取扱説明書 補足

VER.1.01.06

追加項目(P.85) ○出力方式 (対応受信機)・FH5U：RX-491追加, OFH5Uの使用時の注意点追加

追加項目(P.86) ○設定範囲 SXR追加, OSXRの使用時の注意点追加

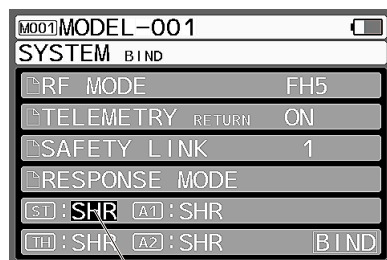
[SXR(エクストリームレスポンス)] ←追加

※SXRのレスポンス モードはFH5U設定時のみ表示されます。

- SXRの対応機器はPGS-LH2, PGS-XB2, PGS-XR2, PGS-CL2, PGS-CX2のみで動作します。
対応機器以外では動作しませんのでご注意ください。
- SXR/SUR/SSR/SHRモードではアナログサーボは動作しませんのでご注意ください。
誤ってSXR/SUR/SSR/SHRモードでアナログサーボを使用すると正常に動作せずサーボが壊れます。
絶対にSXR/SUR/SSR/SHRモードでアナログサーボを使用しないでください。
デジタルサーボ(ERB, ERSシリーズ, Digital ERGシリーズ)の場合はNOR/SHRモードで動作します。
- PGSサーボ(2以外)はSUR/SSR/SHR/NORモード, SRGサーボはSSR/SHR/NORモードで動作します。
- SUPER VORTEX/SV-PLUSシリーズ, HV-12 STOCK SPECIAL, HV-01はSSR/SHR/NORモードで動作します。
- SXR/SUR/SSR/SHRモードではBL-RACER, BL-FORCE, F2000, F2200, F3300, SBL-01/02/03CLは動作しません。
必ずNORモードでご使用ください。
- SV-08, HV-10, HV-12, F2500はNOR/SHRモードで動作します。

Additional contents for P.86

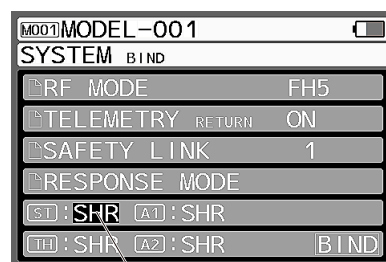
OSetting Range NOR (Normal)
SHR (High Response)
SSR (Super Response)
SUR (Ultra Response)
[SXR (Extreme Response)] ←NEW

※ SXR can be selected only using FH5U RF MODE.

●PGS-LH2, PGS-XB2, PGS-XR2, PGS-CL2, PGS-CX2 are compatible with SXR Mode.

Non compatible devise cannot operate with the SXR Mode.

●Analog servo cannot operate with SXR/SUR/SSR/SHR Mode.

In case of using analog servo with SXR/SUR/SSR/SHR mode, the servo cannot operate and break.

DO NOT use analog servo with SXR/SUR/SSR/SHR mode.
